ADDENDUM NO. 2

May 6, 2022

NEW ADMINISTRATION CENTER, ALTERNATE EDUCATION AND RESOURCE CENTER AND RELATED WORK PROJECT
Crown Point, IN 46307

ADDENDUM TWO

7 DETAIL SLAB EDGE / GUARD
A-411 1 1/2" = 1'-0"

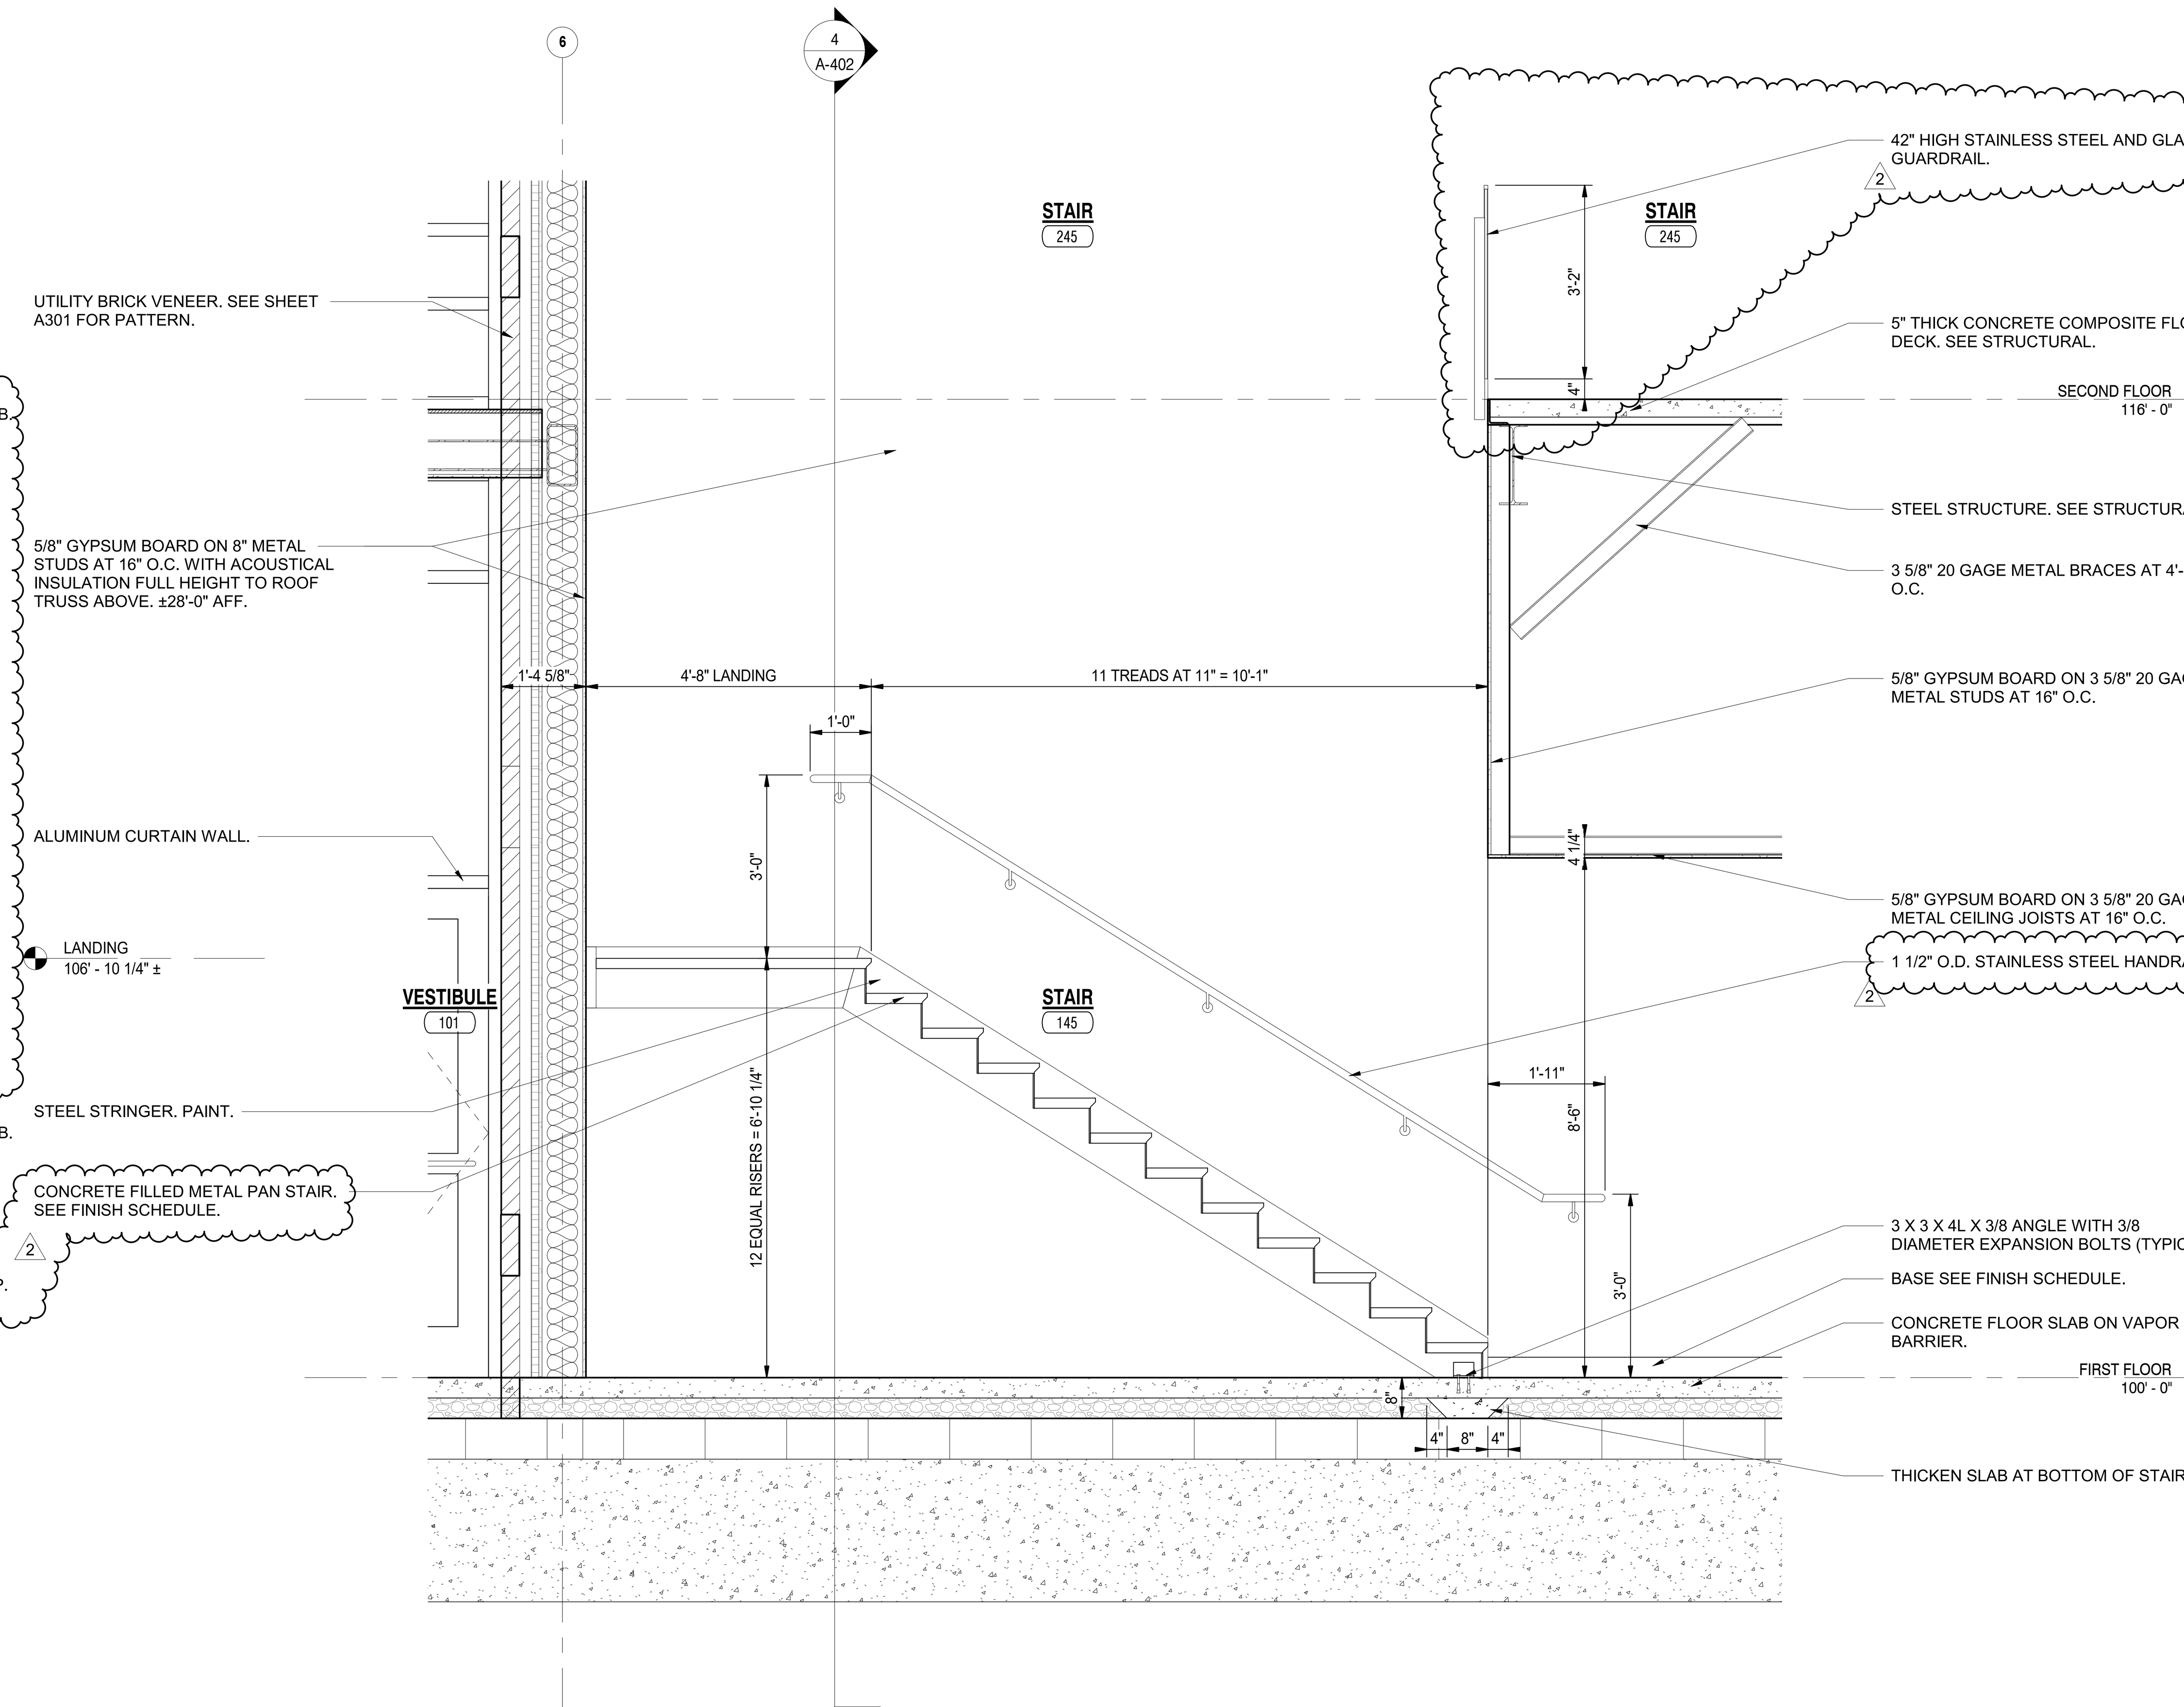
A. Refer to revised, full-size drawing, included in this Addendum, for the following revisions:
   1. Miscellaneous drawing and note revisions.
   2. Change railing at Stair 145/245 to "Stainless steel and glass guardrail and

SHEET A-910

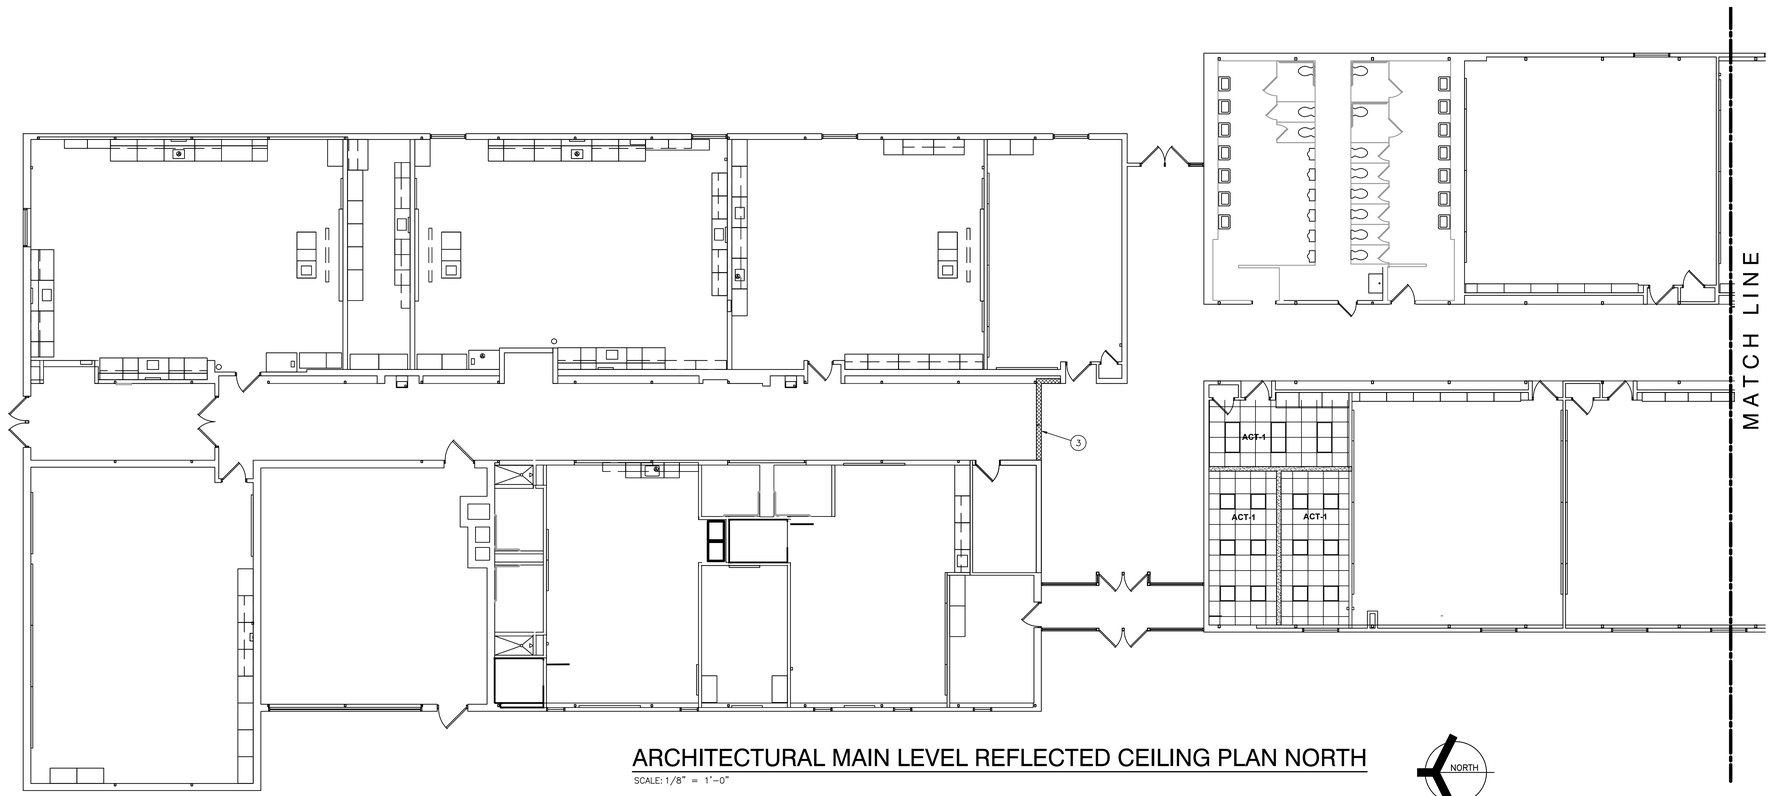
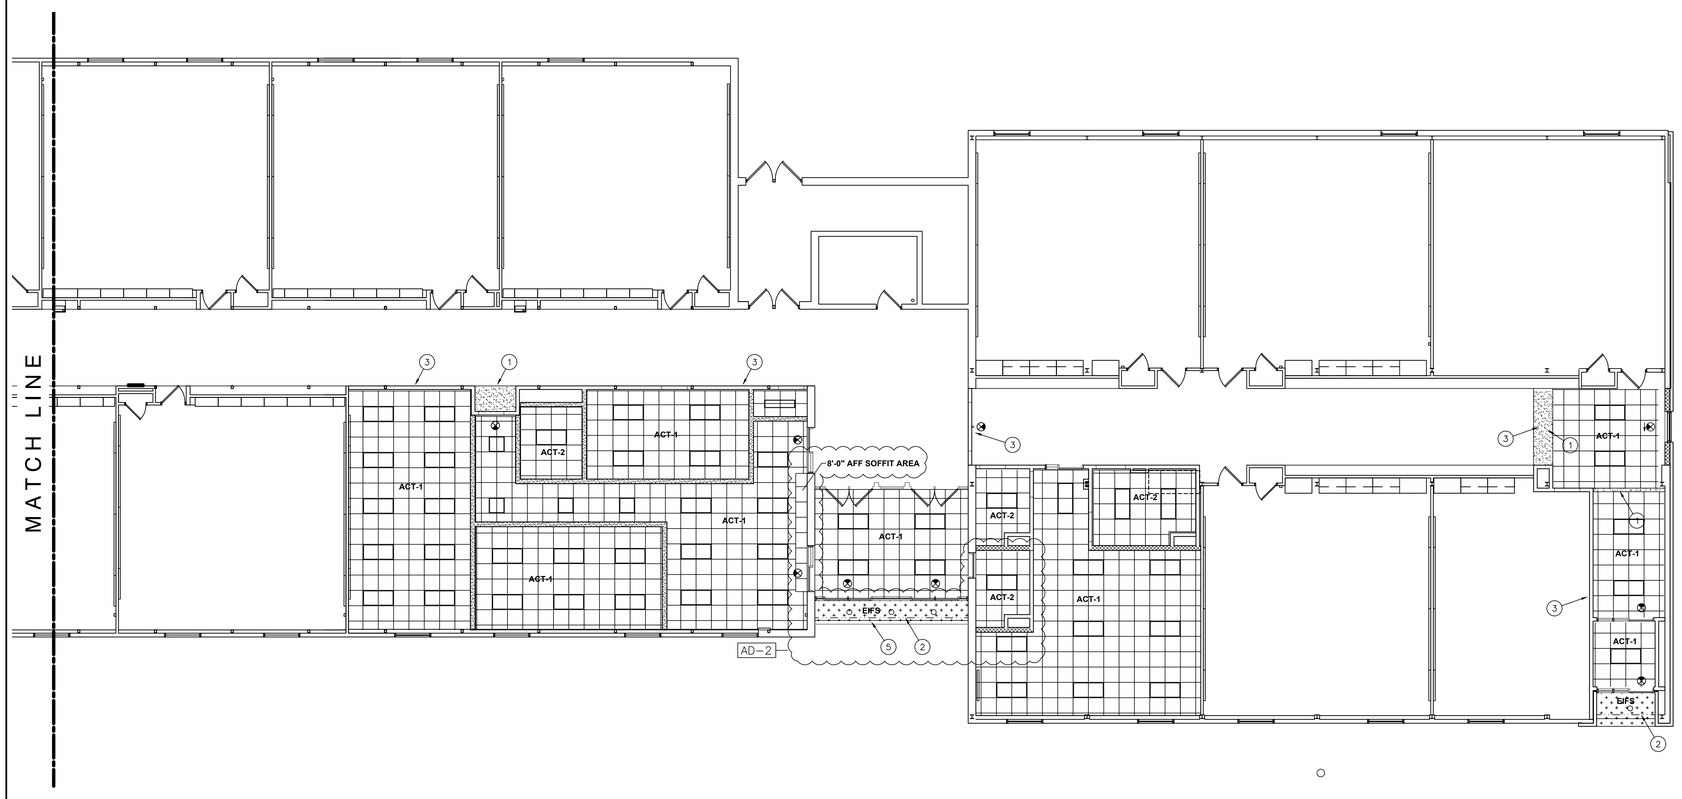
A. Refer to revised, full-size drawing, included in this Addendum, for the following revisions:
   1. Showed general outline of existing ceiling grid to remain.

SHEET
K-200

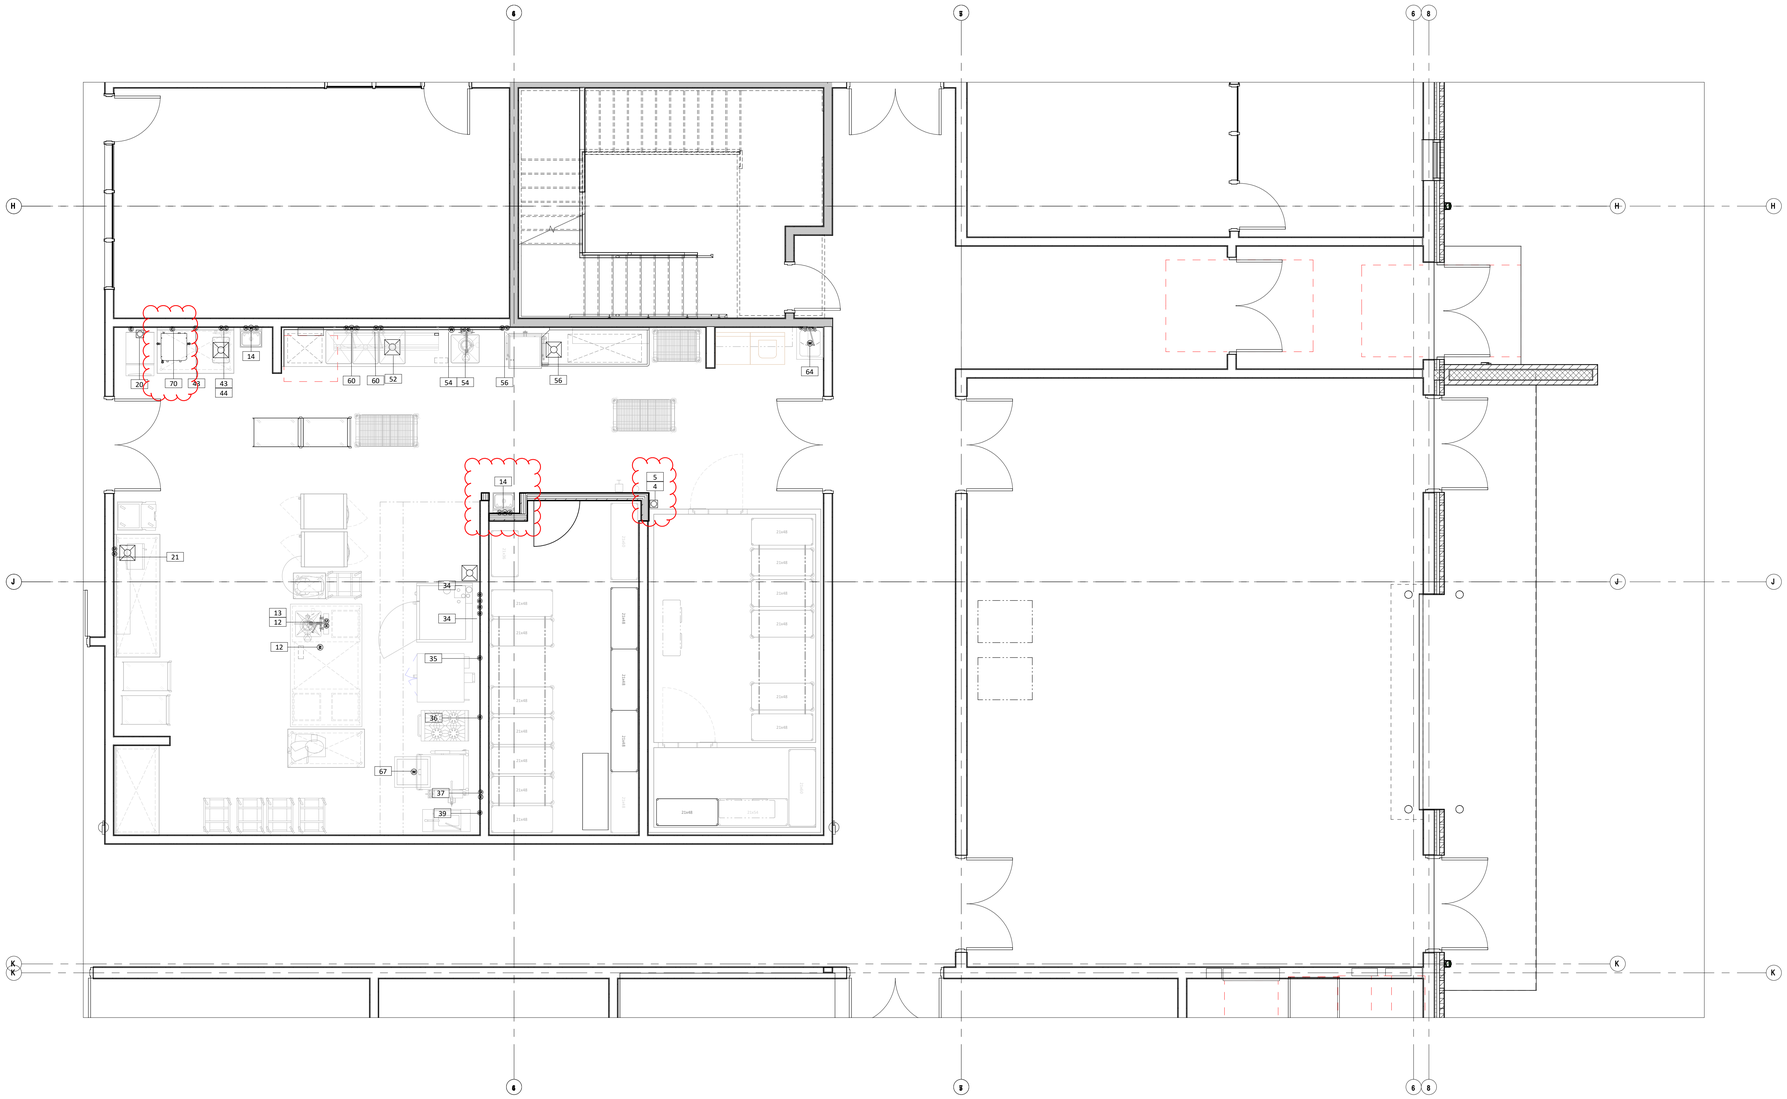
1. Item #70: ADD coffee brewer information.

SHEET
K-300

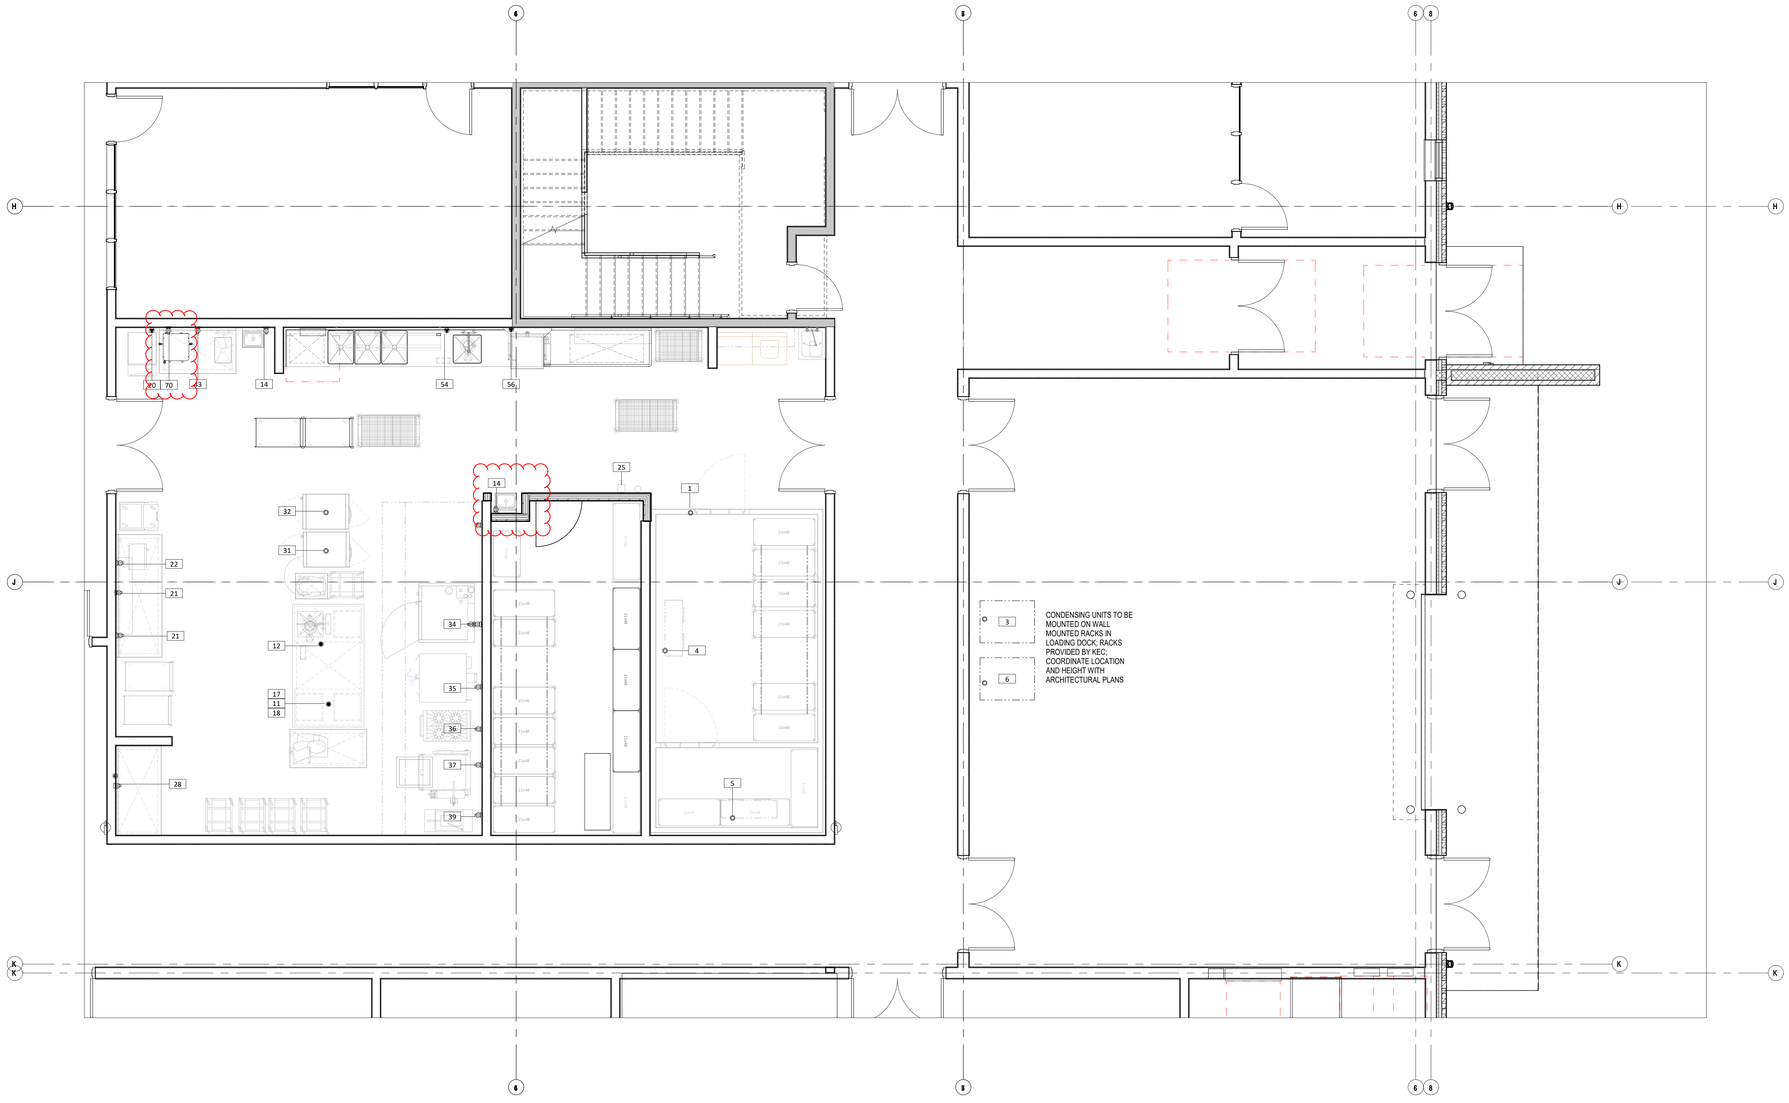
1. Item #14: Revise water for relocated hand sink
2. Item #70 – Revise water for coffee brewer.
